Addendum to “SAR Test Report: R300ds (AXATR-421-A2)”

This report is an addendum to document EUS/CV/R-01:1059/REP (Rev B), “SAR Test Report: R300ds (AXATR-421-A2)”. In this report, additional information supporting the compliance of the R300ds wireless handset is provided. This information is in response to queries by American TCB.

Extrapolation of SAR to the inner surface of the phantom.

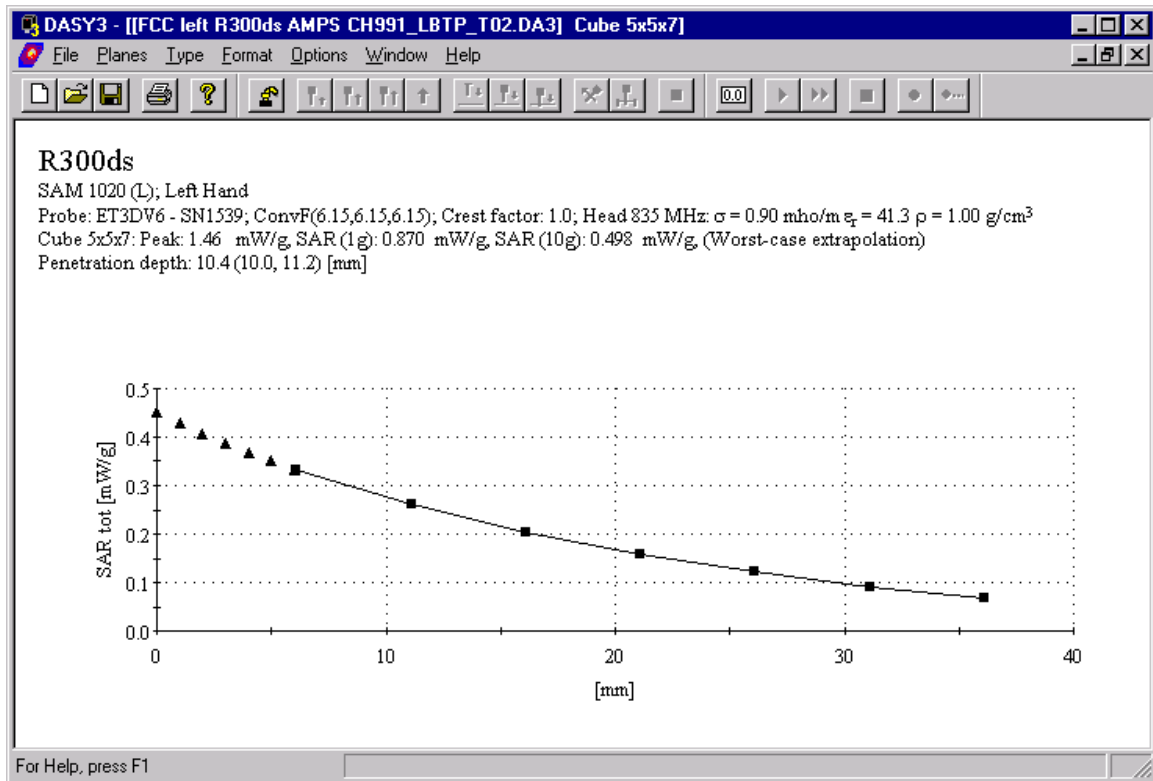
4) A boundary interpolation plot is required.

From a phone conversation, it was made clear that this is referring to extrapolation data along the measurement axis normal to the phantom inner surface. An example plot is given below for the configuration which gives the highest SAR.

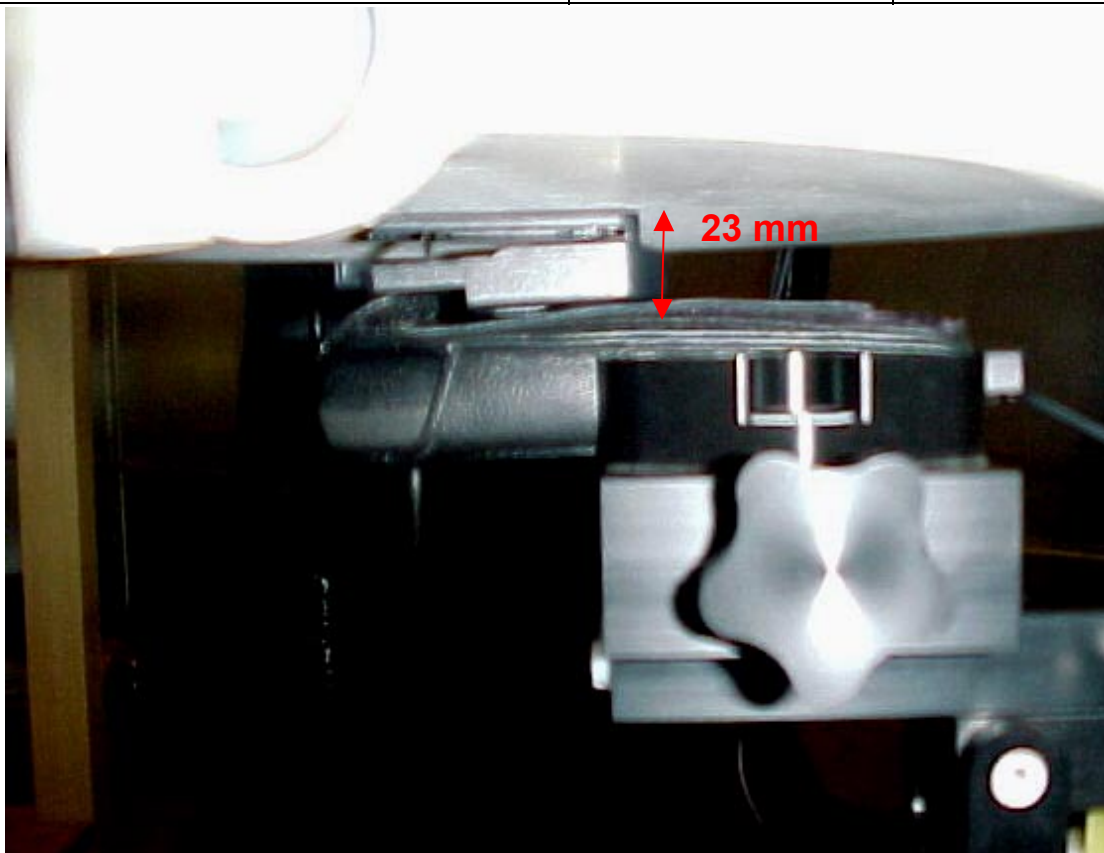
- 9) Please identify distance of phone to phantom (excluding belt clip) for body worn operations. For body worn operations, the device is placed flat against a flat phantom with a 2mm thick shell. The thickness of the carry accessory is 23mm (including both the clip and the leather case). Therefore, at the clip the distance from the handset to the liquid is 25mm. This distance is maintained across the length of the handset, as illustrated below.
